CAA Operational Assessment

Title of airspace change proposal	Temporary Danger Area for BVLOS Operations in the Northern North Sea
Change sponsor	Flylogix Ltd.
Project reference	ACP-2023-083
Account Manager	[REDACTED]
Case study commencement date	
Case study report as at	
<p><i>Instructions</i></p> <p>In providing a response for each question, please ensure that the 'status' column is completed using the following options:</p> <ul style="list-style-type: none"> • YES • NO • PARTIALLY • N/A <p>To aid the SARG Lead it may be useful that each question is also highlighted accordingly to illustrate what is:</p> <p>resolved YES not resolved PARTIALLY not compliant NO</p>

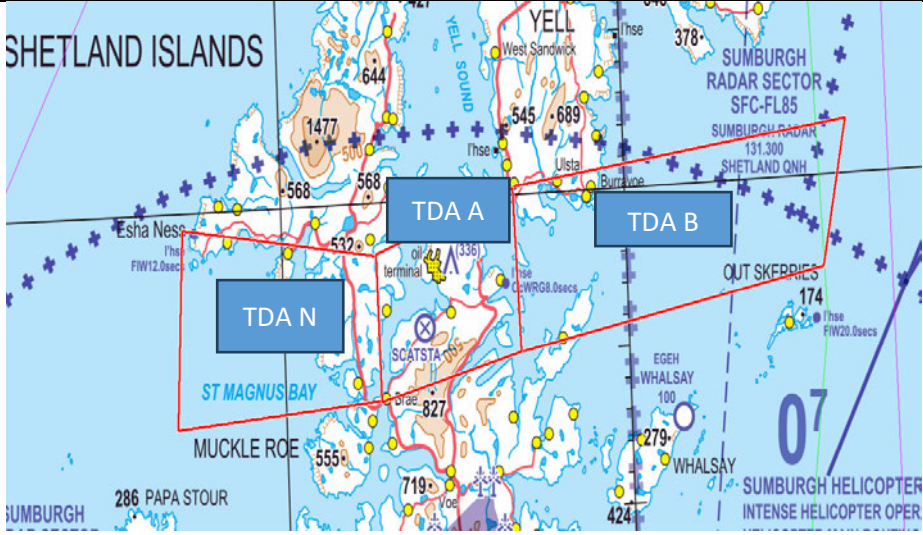
2.1	Is the type of proposed airspace design clearly stated and understood?	YES
<p>Yes, the airspace design is formed by a complex of 19 TDA segments, from surface to 1300ft AMSL:</p>

This accommodates the UAS transiting up to an altitude of 800ft AMSL with operations between 150ft and 600ft near the oil and gas platforms. This allows a 500ft vertical separation between the UAS and upper limit of TDA. Operations are day VFR only. TDA F will not be flown due to close proximity to Norwegian airspace.
